APPLICATION NO.	FILING DATE	FIRST NAMED INVENTOR	ATTORNEY DOCKET NO.	CONFIRMATION NO.
10/717,536	11/21/2003	Michael Chad Hollis	56709.000013	7980
21967 7590 02/14/2008 HUNTON & WILLIAMS LLP INTELLECTUAL PROPERTY DEPARTMENT 1900 K STREET, N.W. SUITE 1200 WASHINGTON, DC 20006-1109			EXAMINER	
			CHOI, STEPHEN	
			ART UNIT	PAPER NUMBER
			3724	
			MAIL DATE	DELIVERY MODE
			02/14/2008	PAPER

Application Number: 10/717,536 Filing Date: November 21, 2003 Appellant(s): HOLLIS ET AL.

EXAMINER'S ANSWER

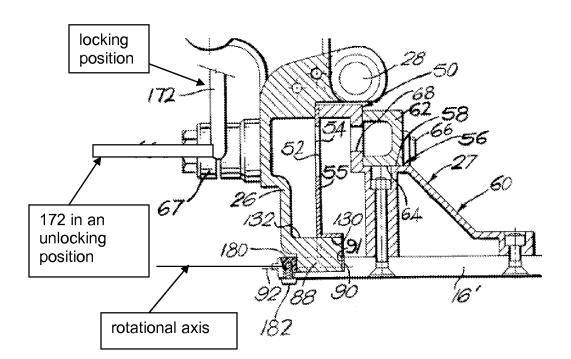
The examiner respectfully disagrees. According to Merriam-Webster Online

Dictionary (definition v. 6a.), "mounted" is defined as "to attach to a support". The

element 172 is attached to the elements 66 wherein the element 66 joins the element

62 to the element 26 which is the saw support assembly. Hence, the bevel angle

locking actuator 172 is indirectly mounted to the saw support assembly 26. In addition, the term "translate" is defined as "changing from one place, state, form, or appearance to another". Merriam-Webster Online Dictionary (definition v. 1a) translate: to bear, remove, or change from one place, state, form, or appearance to another. The bevel locking linkage (e.g., 172) does translate since the element 172 changes from a state of unlocking position to a state of locking position in a direction normal to the first rotational axis. The figure below shows the bevel locking linkage 172 in a locking position which is in a direction normal to the first rotation axis.
